CALIFORNIA COASTAL COMMISSION

**STAFF REPORT: REGULAR CALENDAR**

APPLICATION NO.: 4-97-156

PROJECT DESCRIPTION: Expansion of the existing seawater renewal system
pumphouse, placement of two 2,500 ft. long seawater
intake lines and the construction of a 460 ft. long, 10 ft.
high, 15-37 ft. wide, rock revetment, stairway, access ramp.

EXHIBIT 5 Permit 4-97-156 Revetment Details	
PROJECT NO. 4-97-156 SHEET NO. 15 DATE 12-1-81	DRAWN BY: [Signature] CHECKED BY: [Signature] IN CHARGE: [Signature]

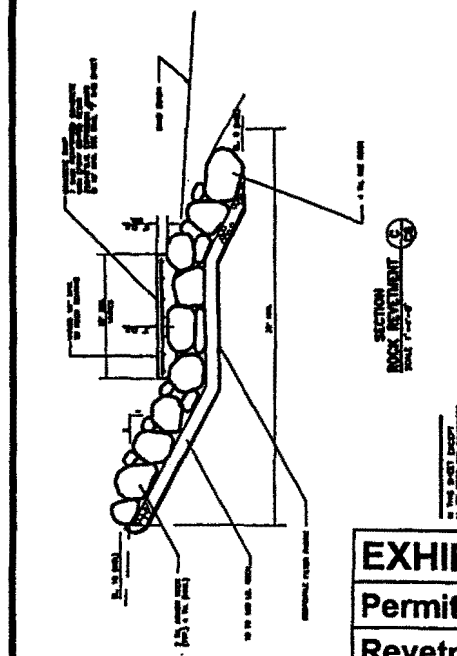
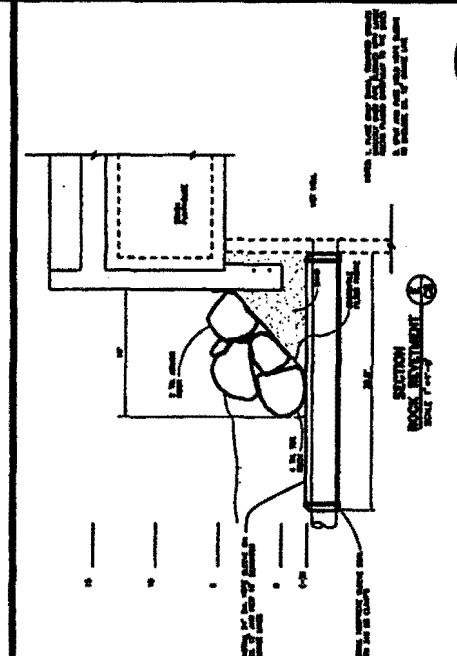
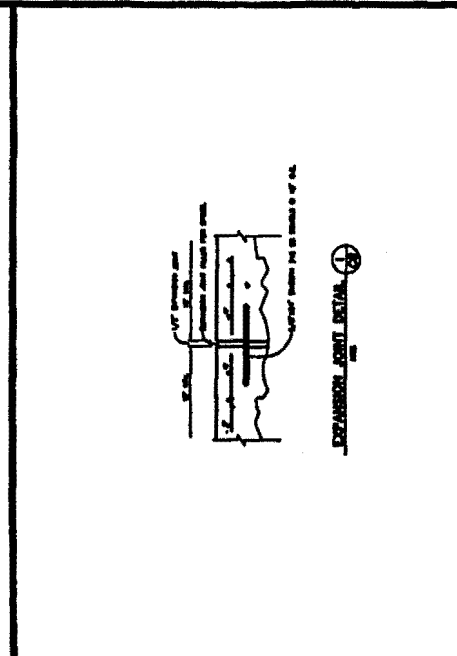
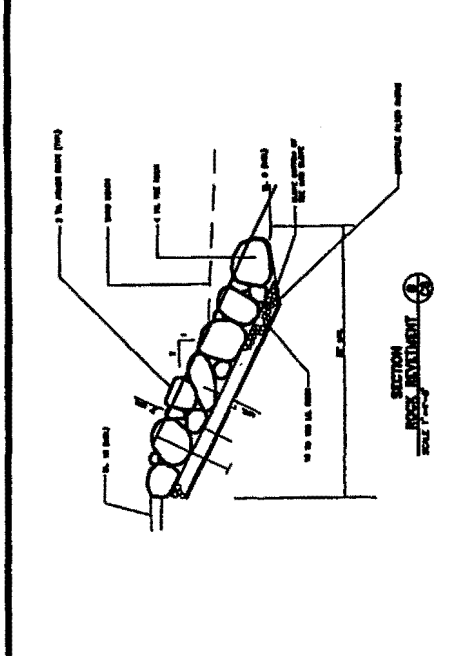
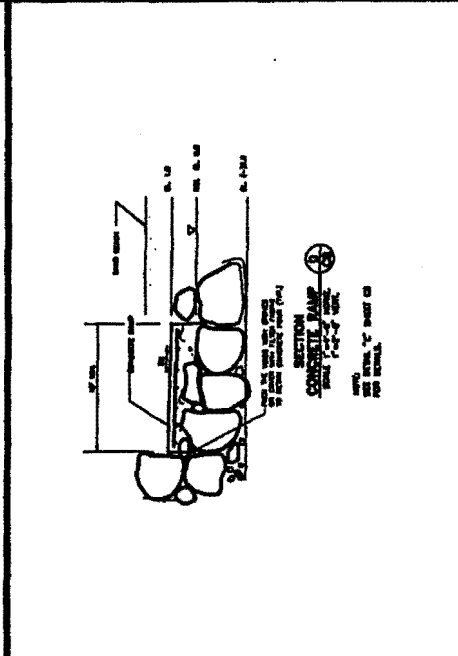
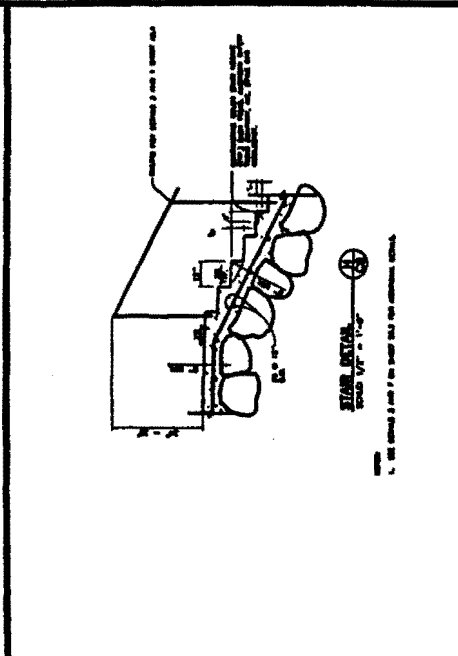
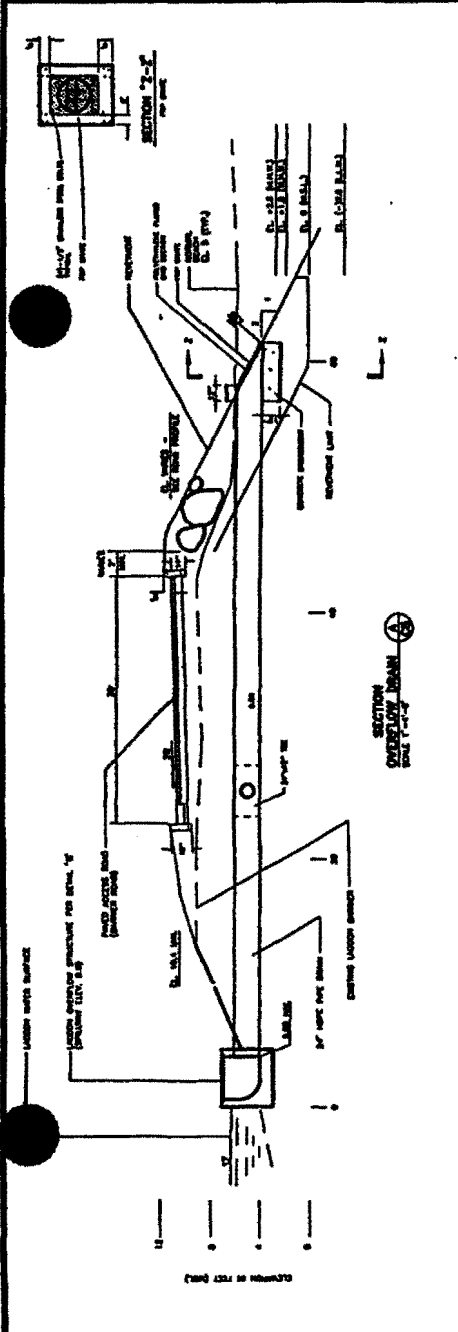
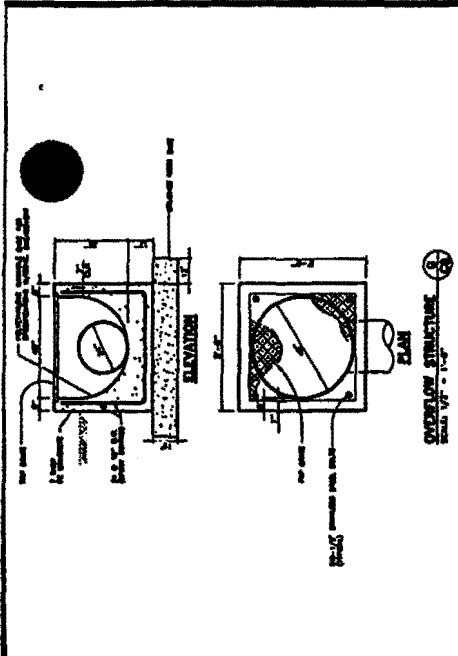
In addition, the question was also raised at the March Commission hearing as to the actual width of the proposed rock revetment. Based on the project plans submitted by the University for the proposed revetment, Commission staff and the University's engineering consultant have agreed that the proposed variable width rock revetment is most accurately described as being between 15 and 37 ft. in width. One difficulty in quantifying the percentage of beach that will be covered by the revetment arises from the seasonal and interannual changes in total beach area. While the area of available beach will fluctuate, the revetment will continue to occupy approximately 10,000 sq. ft. (almost 1/4 acre) of beach. As such, a significant portion of the available sandy beach will be occupied by the proposed rock revetment.

3. The area of the rock revetment footprint on the upper edge of the beach is less than 12% of the total beach measured from mean high tide shown on the topographic map and project site plan, not 25% to 50% as stated in the Staff Report.

Prior to the issuance of the coastal development permit, the applicant shall submit to the Executive Director for review and approval, revised plans prepared by a qualified civil engineer which eliminate the proposed rock revetment.
